Quality Control Check Report. Stage: After Finishing Stage II (Apartments)

GULMOHAR RESIDENCY

Details of Additions & Alterations

Flat No	501	Block no.	* F *
Flat Area	1360 sft	Type	Deluxe / Luxury
Buyer Name	Mrs. Pooja Bushpala & Mr. Chandrashekar B USHPALA		
Phone No.	9502653945	Email

PLUMBING PLAN-1360 Sft (A2-TYPE)

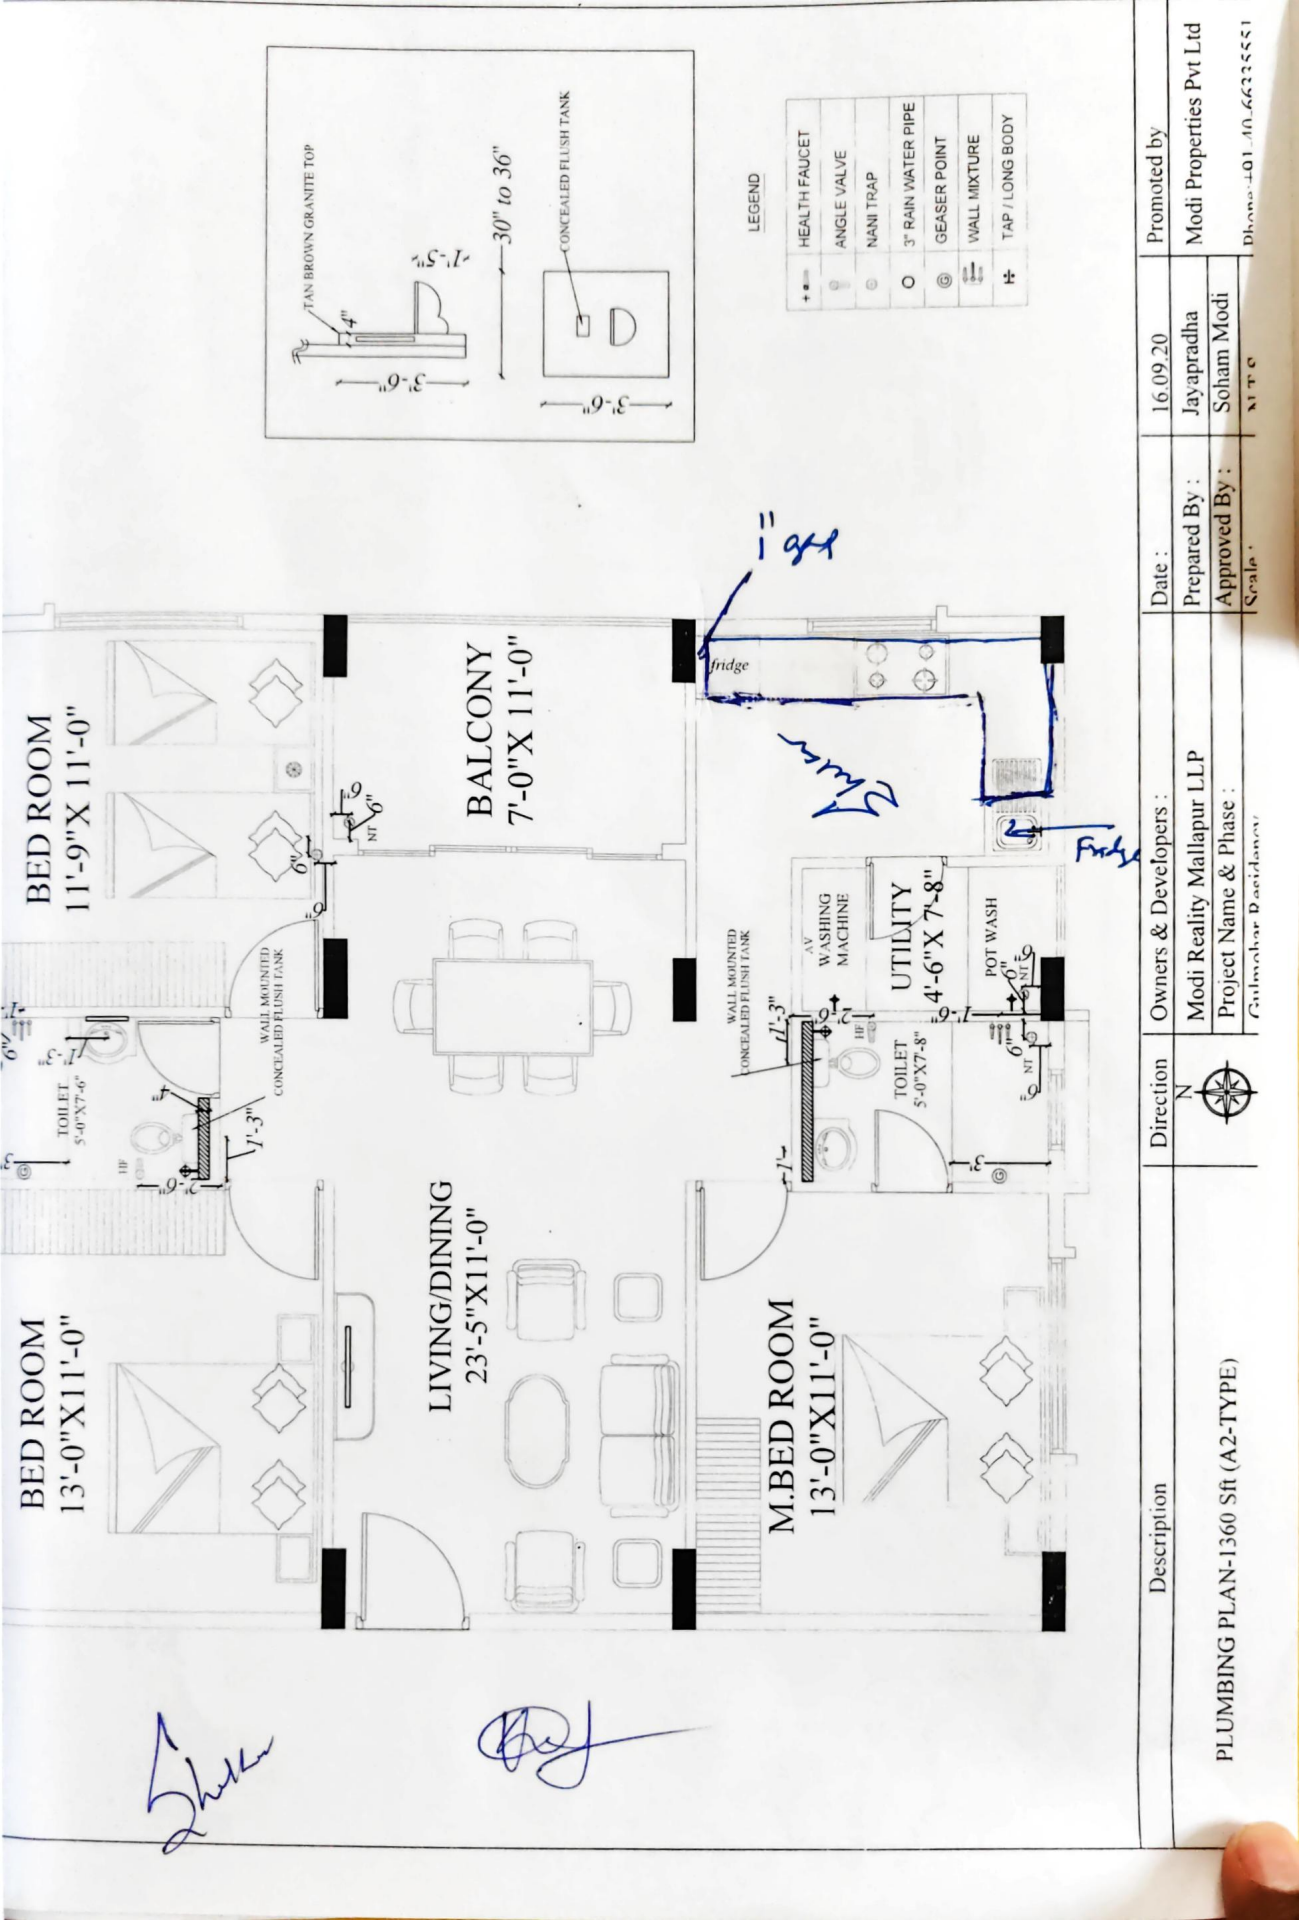
Changes in kitchen platform: (mark on plan)

1) customer goes to modular kitchen (By option)

- ① Door should open in clock wise (right side)
- ② ~~stage~~ Inform me at false ceiling ceiling stage.
